CITY PLANNING COMMISSION

- APPLICATION:**
1. Negative Declaration
 2. Tentative Map to divide 2.6+ vacant acres into 8 condominium lots and one common lot.
 3. Special Permit to create 8 condominium lots with one common lot for a condominium apartment development.
 4. Plan review for the development of 8 apartment structures containing 54 apartment units.

LOCATION: South side of Calvine Road, 500+ feet west of Bruceville Road

TENTATIVE SUBDIVISION MAP P 83400

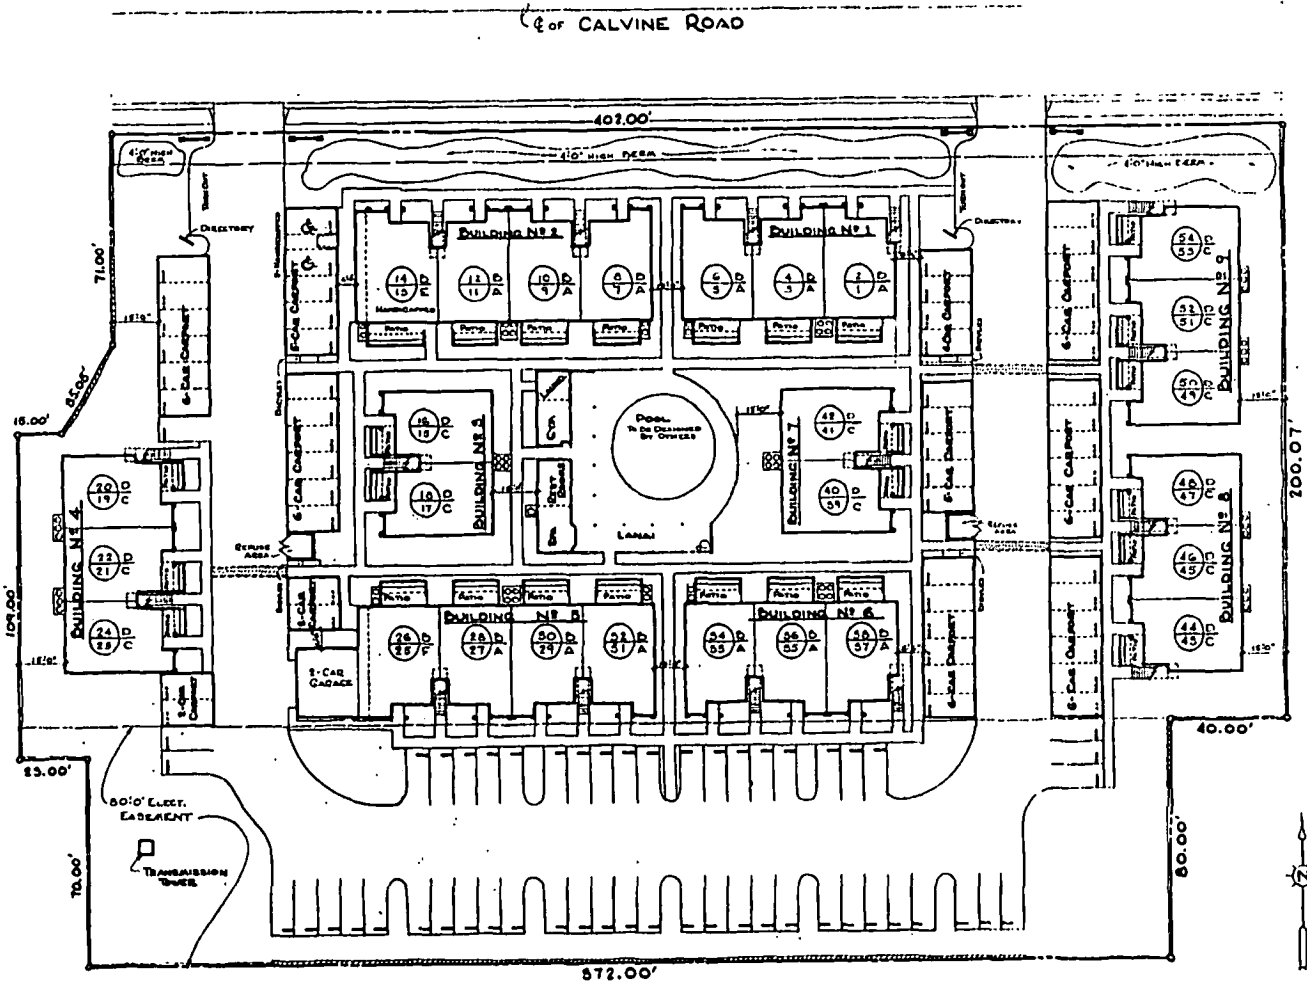
The applicant will need to revise the tentative subdivision map to coincide with the changes made to the site plan.

The tentative subdivision map has been modified to coincide with the revised building footprints.

SITE PLAN

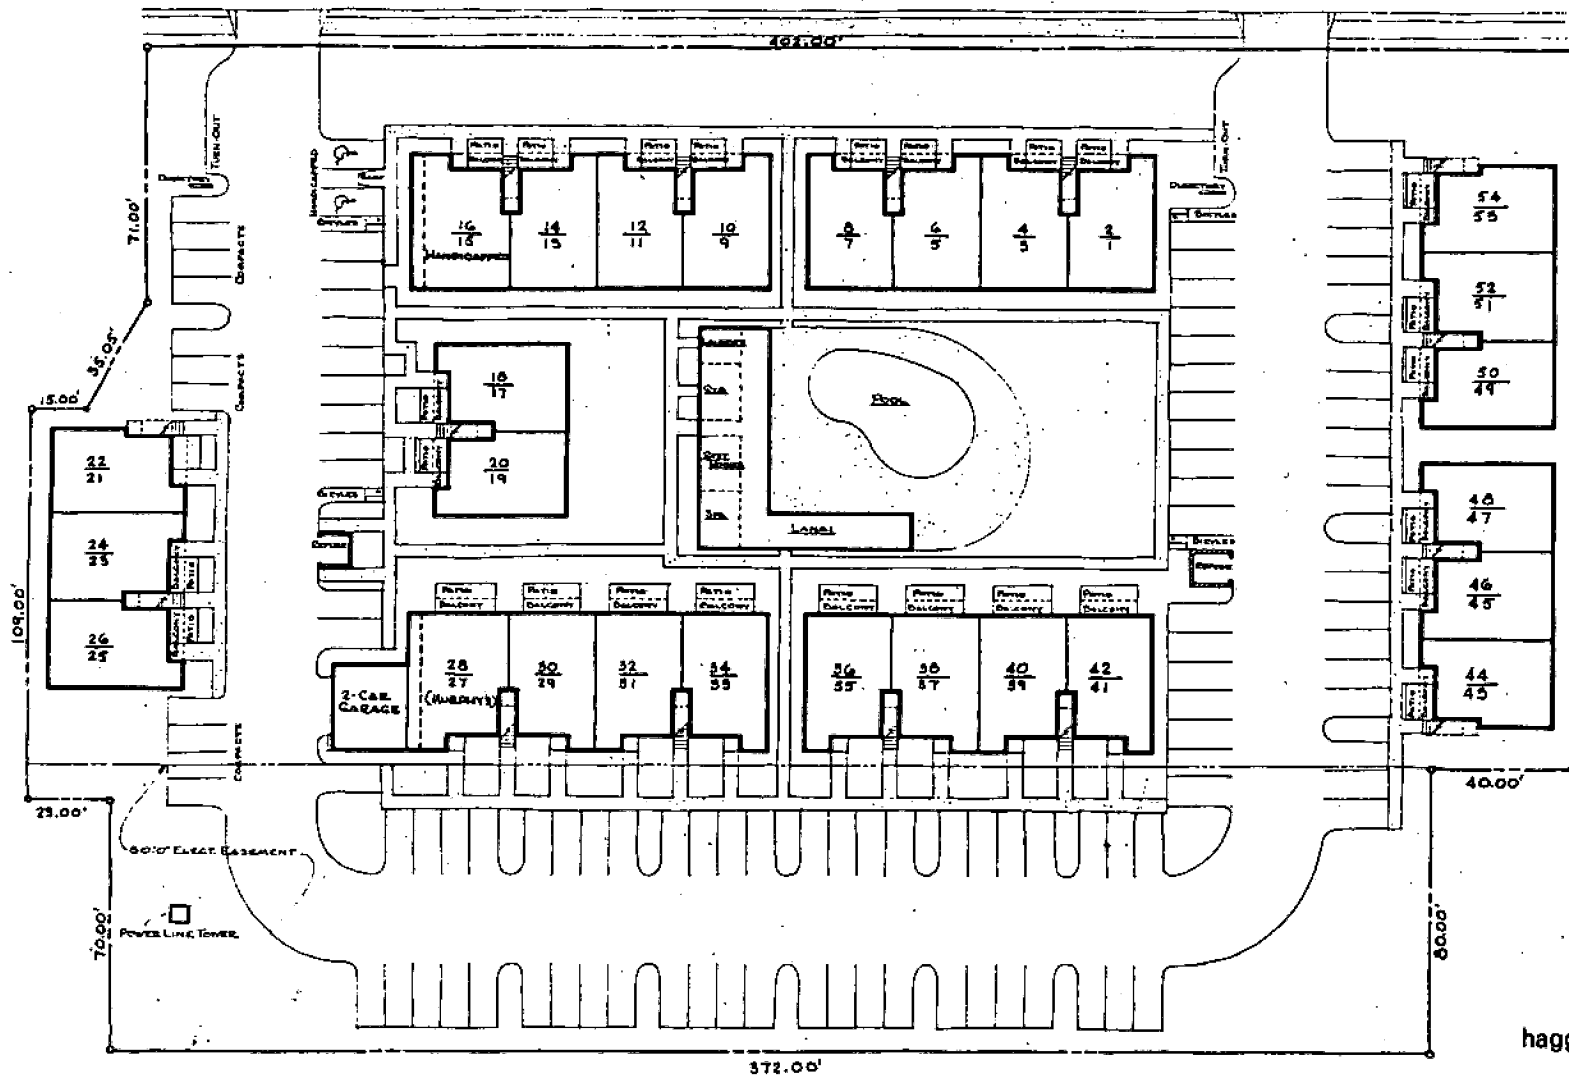
Staff's major concern is related to the close proximity of the two most easterly buildings on the subject site to the existing three and two-story apartment buildings on the adjacent parcel (building separation of only 11 feet). Pursuant to staff's recommendation, the site plan has been revised to provide a 15 foot setback between the two buildings on the subject site and the east property line (building separation of 21 feet between the subject site and adjacent apartment complex).

The applicant also incorporated carport structures for 54 vehicles per staff's recommendation.

Staff has no objection to the revised site plan and tentative map (see Exhibits A and B).

Staff also recommended that the door entries for the two buildings closest to Calvine Road (lots 2 & 3) be relocated from the north to the south elevation in order to discourage on-street parking by tenants. The revised site plan (Exhibit A) still proposes the door entries on the north elevation.

- app* 1) relocate the front entry doors of the proposed structures on lots two and three from the north elevation to the south elevation;
 - 2) develop detailed plans of the proposed bicycle storage facilities.

EXHIBIT C No. 12

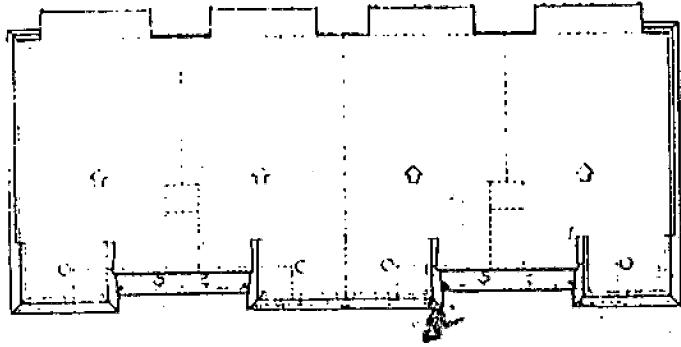
The elevations to the subject project have not changed (Exhibit C). The staff still has concerns regarding the lack of relationship between the facade of the building to the other elevations, the proposed combination of materials and the false front Mansard roof treatment.

It is recommended that the applicant revise the architectural design of the project and the project be referred to the Design Review/Preservation Board for review and approval as previously recommended.
